**SOIL/SITE EVALUATION  
 for ON-SITE WASTEWATER SYSTEM**

STATE - NORTH CAROLINA  
 TOWNSHIP ANDERSON CREEK COUNTY HARNETT  
 SURVEY FOR: PROPOSED PLOT PLAN - LOT - 127  
 WOODSHIRE S/D, PHASE FOUR  
 BENNETT SURVEYS, INC.  
 1662 CLARK RD., LILLINGTON, N.C. 27546  
 (910) 893-9252  
 SURVEYED BY: 40 20 0 20 40  
 FIELD BOOK

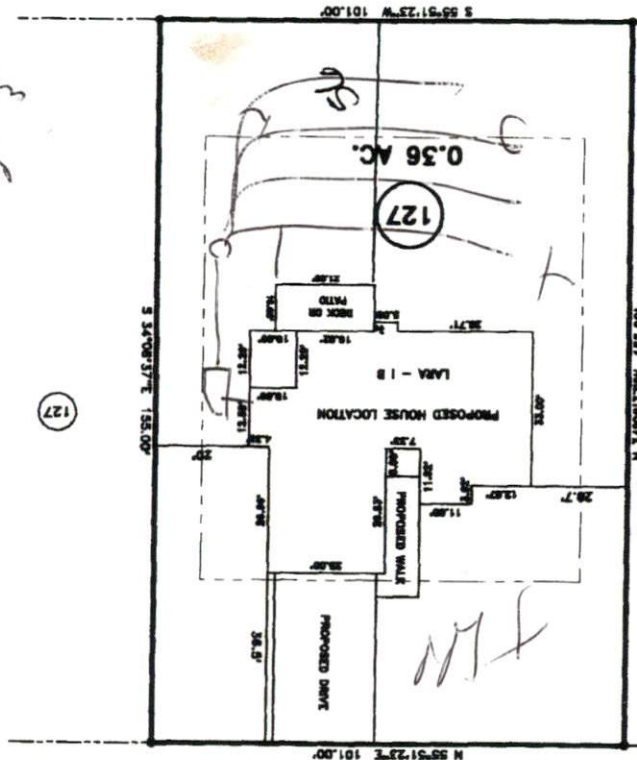
4x75  
 25% lead  
 for 0.36 ac
